Critique
by the Committee to Bridge the Gap
of the
Navy's Draft Five-Year Review
Hunters Point Naval Shipyard

7 September 2018

Asphalt at HPNS made out of HPNS sandblast grit

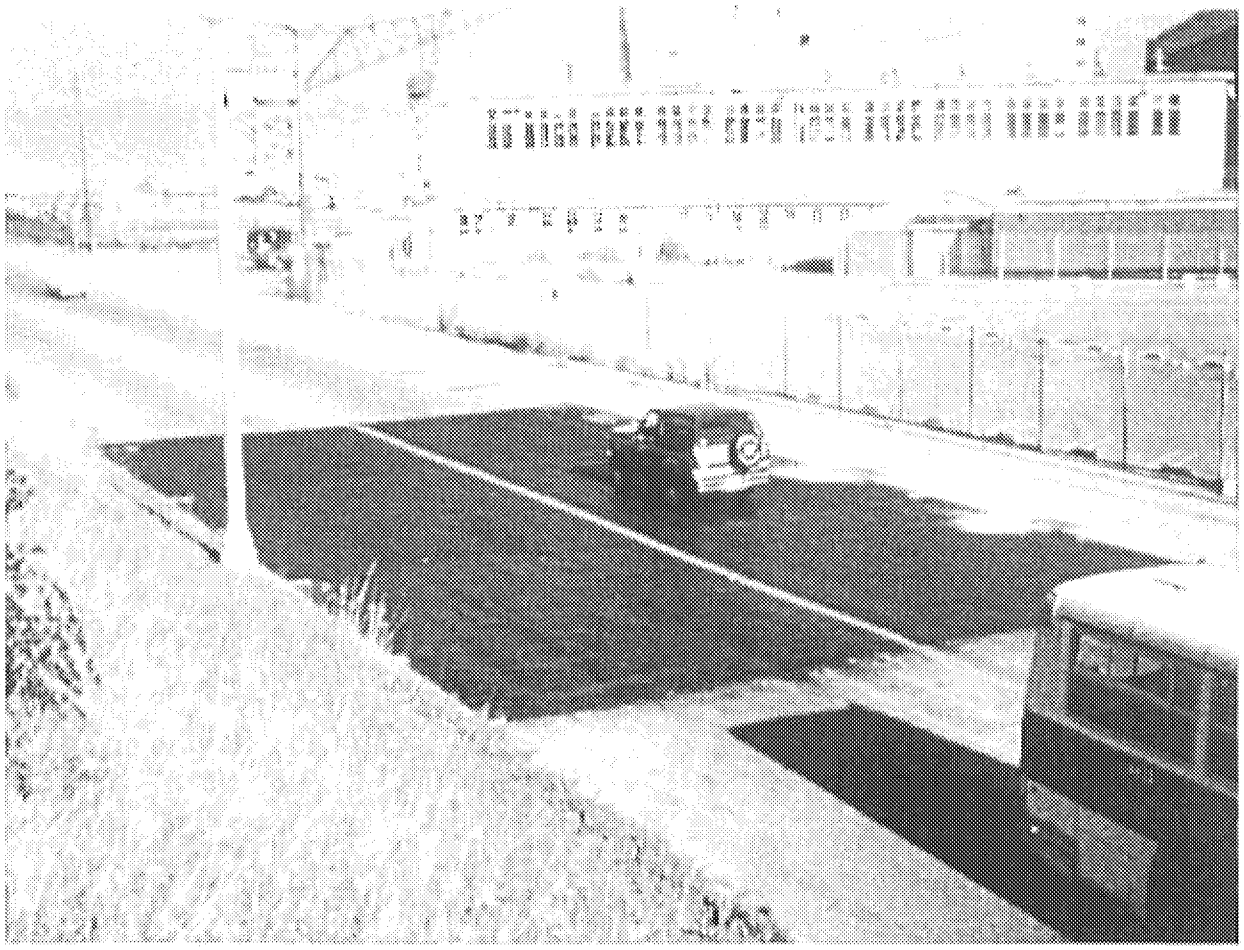
Sandblast grit, from sandblasting scores of contaminated ships from the nuclear testing in the Pacific to decontaminate them, is one of the primary mechanisms of pollution at HPNS. However, there remain questions regarding how much sandblast grit was produced at HPNS, how much has been questionably recycled, how much remains on site and how much placed elsewhere offsite, and the environmental impacts that can follow. This Review does not examine those questions. The only mention of Sandblast grit recycling in the Five-Year Review is the following statement, "[b]etween 1991 and 1995, the Navy collected nearly 5,000 tons of sandblast grit from multiple areas at HPNS. The material was sent to an asphalt plant for reuse in an asphalt mix."(page 3-1). This brief utterance fails to disclose that some of the asphalt was brought back to the site to be used to produce and install asphalt with the contaminated grit.

There is no consideration in the Five-Year Review of the protectiveness or danger of either the HPNS asphalt or Central Valley asphalt made with potentially contaminated sandblast grit.

Hand-held radiation scan of sandblast grit prior to use in asphalt

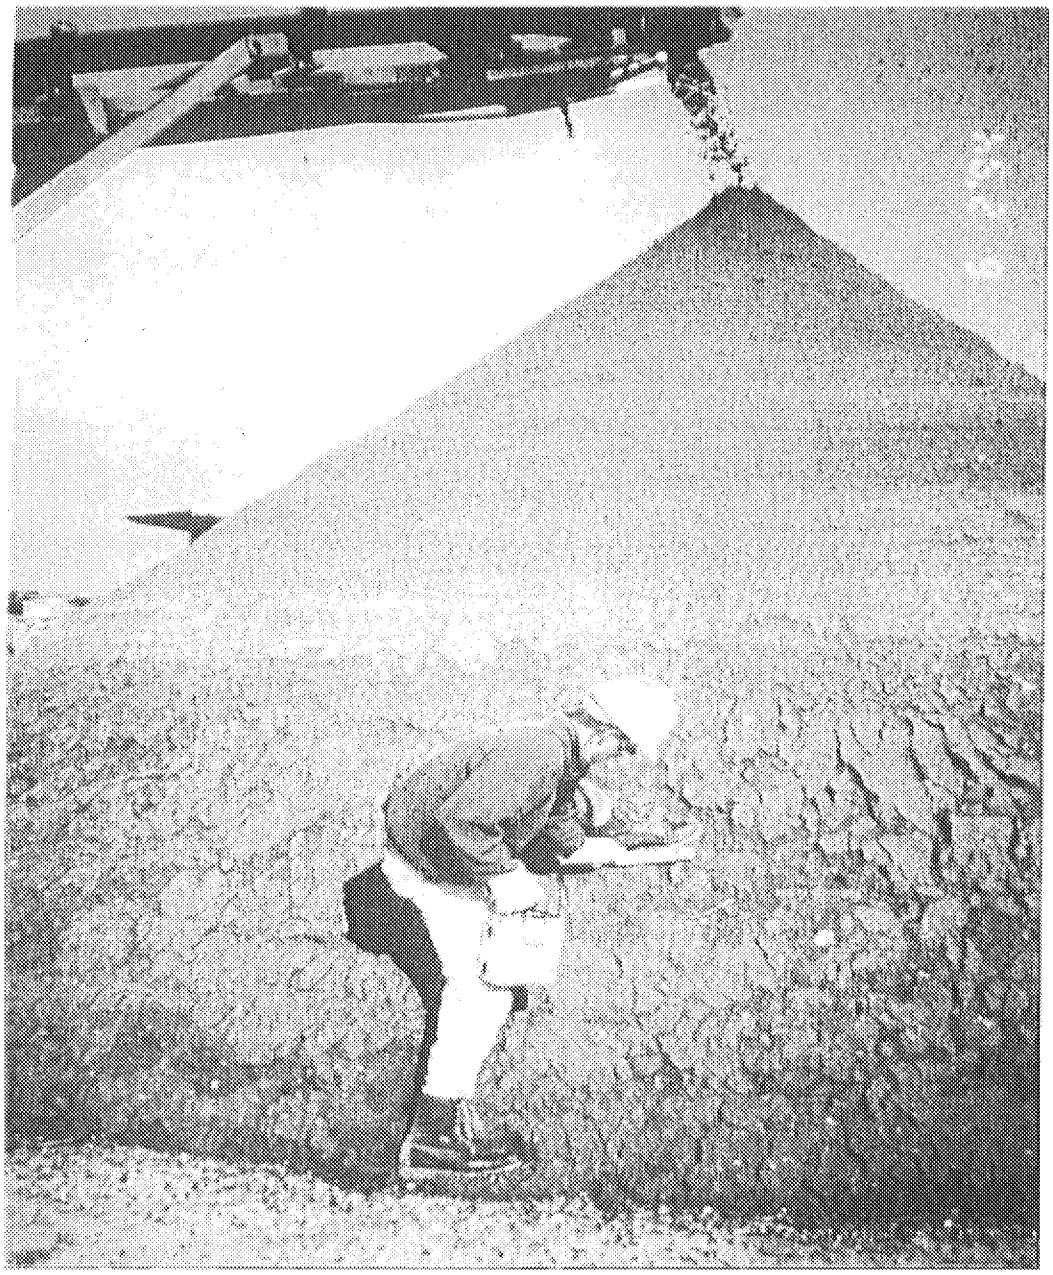
Other documents indicate that large amounts of additional potentially contaminated grit was sent to the Central Valley to be made into asphalt for use there.[6] The method for determining whether there was radioactivity in the sandblast grit (and subsequent asphalt) appears primitive at best – a handheld Geiger-counter type device that is unlikely to be able to detect radionuclides at the level of concern.
